CERTIFICATE OF APPROPRIATENESS

Property: 1604 North Boulevard, Lot 8, Block 2, Edgemont Subdivision. The property includes a historic Mediterranean style residence, with 8,661 square foot of living space and is situated on a 15,000 square foot interior lot.

Proposal: Alteration – Addition

Recommendation: Partial Approval: Denial to construct skylight addition and approval of all other exterior work.

SOUTH ELEVATION – FRONT FACING NORTH BOULEVARD

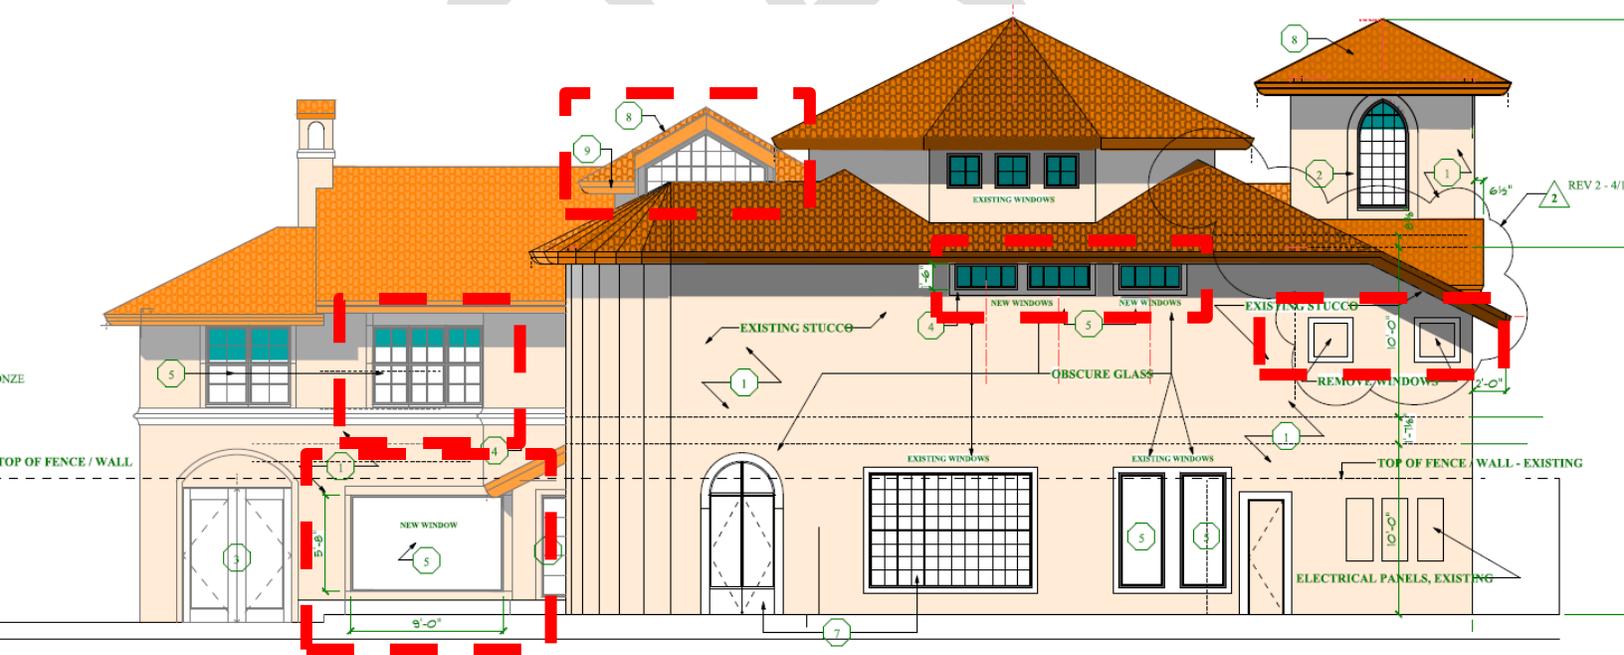
- (b) The proposed activity must match the architectural features, materials, and character of either the existing noncontributing structure or the contributing structures within the context area.
The addition of a "dormer skylight" to this structure does not match the existing house, nor is it compatible to the style of architecture, historic character and the appearance of contributing structures in Boulevard Oaks Historic District. Furthermore, the skylight will be highly visible on the roof facing the street.

3. I believe that the new plans likely violate the objective height limits imposed by the Edgemont deed restrictions. Not shown the front elevation drawing that was submitted to establish height compliance by reference to an apparent “dormer” in that drawing, are the skylights that are shown, in another drawing, to obtrude above the peak of the apparent “dormer”. The Architectural Committee advised the 1604 North Boulevard property owner’s architect of this concern about height violation when it responded to the second set of plans, but the third set of plans did not address this concern and there has been no other response to that question.

4. What appears to be a “dormer” in the front elevation drawing is actually the front prow of a new north-south roofline that is to be topped with the protruding skylights. There is nothing like that in all of the Boulevard Oaks Historic District, and nothing like that should be allowed unless it can be demonstrated that it would not be visible from outside the property.

WEST SIDE ELEVATION

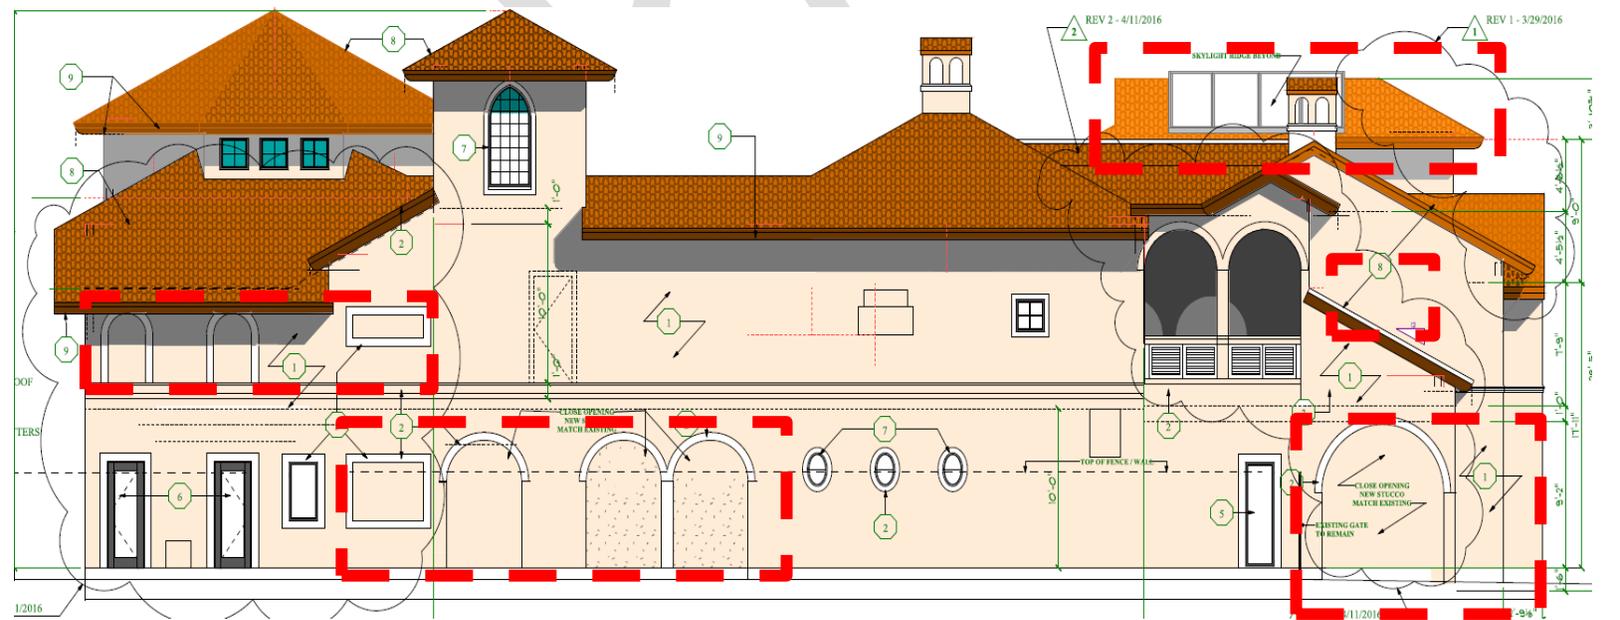
2. The structures at 1604 North Boulevard are already massively invasive of the side property line setbacks prevailing throughout the Boulevard Oaks Historic District, to the substantial detriment of the property owners to the immediate west of 1604 North Boulevard. I object to the huge and virtually unrelieved wall that is now proposed for the west façade of these invasive structures.

ROOF PLAN PROPOSED

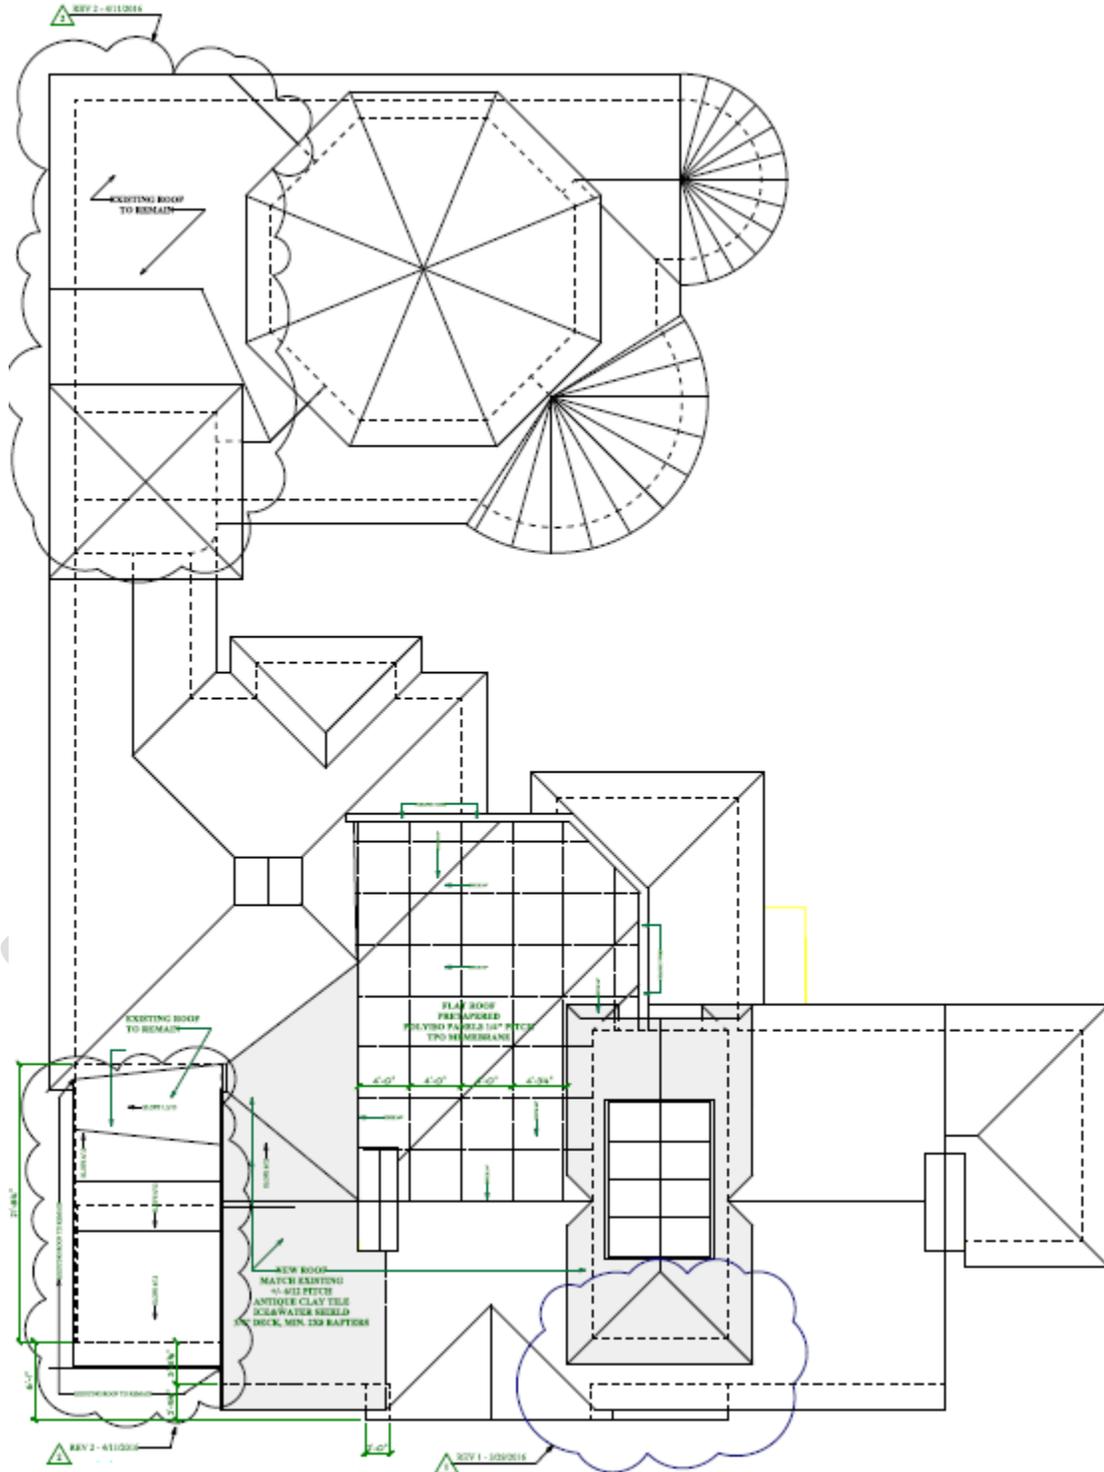
- (a) The proposed activity must recognize the building, structure, object or site as a product of its own time and avoid alterations that seek to create an earlier or later appearance; and
The addition of the skylight alters the low rooflines of the 1920s residence and later additions which alters the character of the building. Therefore, if the skylight were removed, the project would meet this criterion.

- (b) The noncontributing structure with the constructed addition is compatible with the typical proportions and scale of existing contributing structures in the context area.
The proposed skylight adds approximately 4' to the low roofline which is compatible with ridge heights of existing residences. However, the large skylight creates a massing on top of the residence that is not found on other properties within the context area. Therefore, if the skylight were removed, the project would meet this criterion.
